Office Action Summary

10/643,071

LUM, PAUL

FIG. 6A

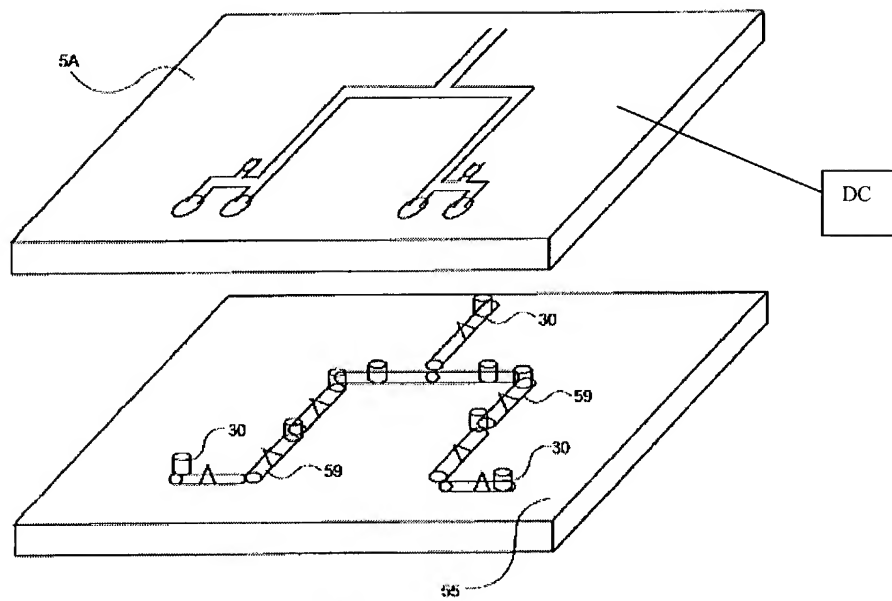
With respect to claim 1, **Kamholz** teaches a disposable cartridge DC comprising: a network of conduits 12, 14 and reservoirs 35, 37 within said cartridge, at least one micro-pump MP fluidly coupled to said network for transporting small volumes of biological fluid, said pump comprising: a rotatable portion having a magnetic core 30m and configured to be rotatable by alternating inductive magnetic fields to urge fluid through said network. See particularly **Figures 6A, 10** and column 1 lines 22-24 of Kamholz.

With respect to claim 6, **Kamholz** teaches a device comprising: a disposable cartridge DC, a network of conduits 12, 14 and reservoirs 35, 37 within said cartridge; a micro-pump MP fluidly coupled to said network for transporting small volumes of biological fluid, said pump comprising a rotatable portion configured to be rotatable by alternating inductive magnetic fields to urge fluid through said network; an external electromagnet (column 3 lines 37-38; column 4 lines 47-49; column 9 lines 25-26) providing said alternating inductive magnetic fields for causing the rotatable portion to move to transport small volumes, said electromagnet positioned external of said disposable cartridge and fluidically isolated from said micro-pump. See particularly **Figures 6A, 10** of Kamholz.

With respect to claim 7, **Kamholz** teaches that said electromagnet is reused with successive disposable cartridges and the rotatable portion is contained in the cartridge and does not contaminate the electromagnet. See particularly **Figures 6A, 10**; column 3 lines 37-38; column 4 lines 47-49; column 9 lines 25-26 of Kamholz.

With respect to claim 9, **Kamholz** teaches the actual pumping mechanism of the micro pump is completely isolated from said external electromagnet. See particularly **Figures 6A, 10**; column 3 lines 37-38; column 4 lines 47-49; column 9 lines 25-26 of Kamholz.

Kamholz teaches that the invention can be used for several applications such as: biomedical, medical (i.e., blood, medicine, etc), biothechnical, etc. **Kamholz** does not teach that the rotatable portion does not exceed the level that the level that would puncture or damage the blood cells. However, it is well known in the art that one design consideration when designing a blood pump is to prevent the pump from degrading the quality of the blood by damaging the blood cells. Therefore, it would have been obvious to one of ordinary skill in the art at the time the invention was made to have designed **Kamholz's** rotatable portion in a way that it would have not damage the blood cells so as to prevent degradation of the quality of the blood being pumped to a patient. See particularly **Figures 6A, 10** and column 1 lines 22-24 of Kamholz.
